Problem:

Temperature control system can not hold temperature steady.

Figure 1

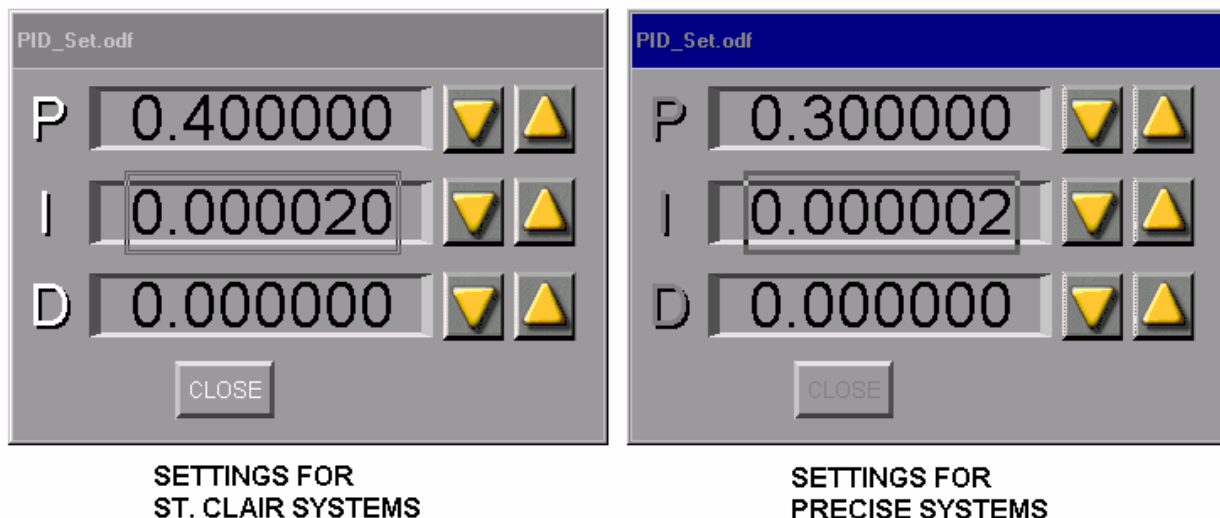
The temperature fluctuates constantly, varying more than ± 5 degrees F. The variation in temperature contributes to the variation in volume being dispensed.

The PID values for the temperature controller are not optimized.

Set the PID values as shown in figure 1.

The new PID screens should be installed so that numbers smaller than 0.1 can be seen.

1. Copy TEMP-FIX.EXE to AutoStream hard drive and execute. This installs new PID entry screens.
2. In the settings screen of the AutoStream software, tap the PID button on the Temperature Controller.
3. Enter the values shown in Figure 1.

The new settings **will not** control the temperature so that the actual temperature is the set point.

The new settings **will** stabilize the temperature so that it does not fluctuate greater than ± 2 deg F.
The actual temperature **will** be lower than the set point.
